IEEE 802.3 September 2025 Interim IEEE P802.3dj Task Force

Update – Optical MDI's Normative Connector Position(s) Comments #220-223

John D'Ambrosia, Futurewei, U.S. Subsidiary of Huawei
Angela Lambert, Corning
Tiger Ninomiya, Accelink
Jose Castro, Panduit

Figure 180A–2—Optical lane assignments for a single-row 12-position connector

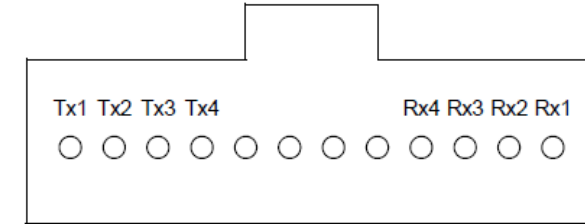
- **#220 (TR):** This paragraph primarily addresses a single application where the connector is fully populated with fibers in the Tx1-4 and Rx1-4 positions. There is another application space where these positions are not fully populated with fibers - and may be populated to support a single PMD such as 200GBASE-DR1, 400GBASE-DR2, or 800GBASE-DR4. This section needs to address both application spaces

- **#222 (TR):** This text indicates that the Optical lane assignments for the connector can support different combinations of PMDs, but it does not make a normative reference to the assignment of grouping(s) of signals assigned to a given PMD

Figure 180A–2 shows the generic layout of a single-row 12-position optical connector specified for single-lane, 2-lane and 4-lane optical PMDs. The four transmit and four receive optical lanes shall occupy the positions depicted in Figure 180A–2 when looking into the MDI receptacle with the connector keyway feature on top. The four center positions are unused. Figure 180A–2 also provides details on the ordering of the optical connector positions.

When the optical MDI is only supporting a single one-lane PMD (200GBASE-DR1 or 200GBASE-DR1-2), the optical lanes SHALL be assigned to the optical connector positions Tx1 and Rx1, as shown in Table 180A-2, regardless of whether fibers are populated in the remaining optical connector positions.

When the optical MDI is only supporting a single two-lane PMD (400GBASE-DR2 or 400GBASE-DR2-2), the optical lanes SHALL be assigned to the optical connector positions Tx1 / Tx2 and Rx1 / Rx2, as shown in Table 180A-2, regardless of whether fibers are populated in the remaining optical connector positions.

When the optical MDI is supporting a single four-lane PMD (800GBASE-DR4 or 800GBASE-DR4-2), the optical lanes SHALL be assigned to the optical connector positions Tx1 through Tx4 and Rx1 through Rx4, as shown in Table 180A-2.

Alternatively, combinations of one-lane optical PMDs, i.e. 200GBASE-DR1 or 200GBASE-DR1-2, and / or two-lane optical PMDs, i.e. 400GBASE-DR2 or 400GBASE-DR2-2, are permissible when fibers are populated in all of the optical connector positions. For two-lane PMDs, the optical lanes SHALL be assigned to the optical connector positions for a given 400GBASE-DR2 or 400GBASE-DR2-2 PMD # in Table 180A-2.

Figure 180A–3—Optical lane assignments for a single-row 16-position connector

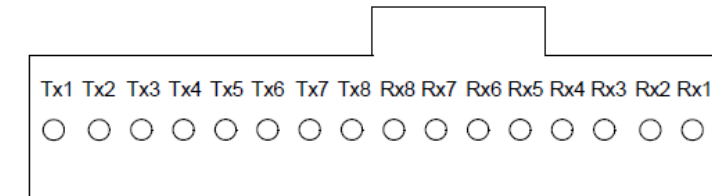
- **#221 (TR):** This paragraph primarily addresses a single application where the connector is fully populated with fibers in the Tx1-8 and Rx1-8 positions. There is another application space where these positions are not fully populated with fibers - and may be populated to support a single PMD such as 200GBASE-DR1, 400GBASE-DR2, 800GBASE-DR4, or 1.6TBASE DR8. This section needs to address both application spaces.

- **#223 (TR):** This text indicates that the Optical lane assignments for the connector can support different combinations of PMDs, but it does not make a normative reference to the assignment of grouping(s) of signals assigned to a given PMD

Figure 180A–3 shows the generic layout of a single-row 16-position optical connector specified for single-lane, 2-lane, 4-lane and 8-lane optical PMDs. The eight transmit and eight receive optical lanes shall occupy the positions depicted in Figure 180A–3 when looking into the MDI receptacle with the connector keyway feature on top. Figure 180A–3 also provides details on the ordering of the optical connector positions.

When the optical MDI is only supporting a single one-lane PMD (200GBASE-DR1 or 200GBASE-DR1-2), the optical lanes SHALL be assigned to the optical connector positions Tx1 and Rx1, as shown in Table 180A-4, regardless of whether fibers are populated in the remaining optical connector positions.

When the optical MDI is only supporting a single two-lane PMD (400GBASE-DR2 or 400GBASE-DR2-2), the optical lanes SHALL be assigned to the optical connector positions Tx1 / Tx2 and Rx1 / Rx2, as shown in Table 180A-4, regardless of whether fibers are populated in the remaining optical connector positions.

When the optical MDI is only supporting a single four-lane PMD (800GBASE-DR4 or 800GBASE-DR4-2), the optical lanes SHALL be assigned to the optical connector positions Tx1 / Tx2 / Tx3 / Tx4 and Rx1 / Rx2 / Rx3 / Rx4, as shown in Table 180A-4, regardless of whether fibers are populated in the remaining optical connector positions.

When the optical MDI is supporting a single eight-lane PMD (1.6TBASE-DR8 or 1.6TBASE-DR8-2), the optical lanes SHALL be assigned to the optical connector positions Tx1 through Tx8 and Rx1 through Rx8, as shown in Table 180A-4.

Alternatively, combinations of one-lane optical PMDs, i.e. 200GBASE-DR1 or 200GBASE-DR1-2, and / or two-lane optical PMDs, i.e. 400GBASE-DR2 or 400GBASE-DR2-2, and / or four-lane optical PMDs, i.e. 800GBASE-DR4 or 800GBASE-DR4-2 are permissible when fibers are populated in all of the optical connector positions. For two-lane PMDs, the optical lanes SHALL be assigned to the optical connector positions for a given 400GBASE-DR2 or 400GBASE-DR2-2 PMD # in Table 180A-4. For four-lane PMDs, the optical lanes SHALL be assigned to the optical connector positions for a given 800GBASE-DR4 or 800GBASE-DR4-2 PMD # in Table 180A-4. Table 180A–5 shows an example of a combination of the mapping of several optical PMDs to a single row, 16-position optical connector with fibers populated in optical connector positions Tx1 through Tx8 and Rx1 through Rx8.
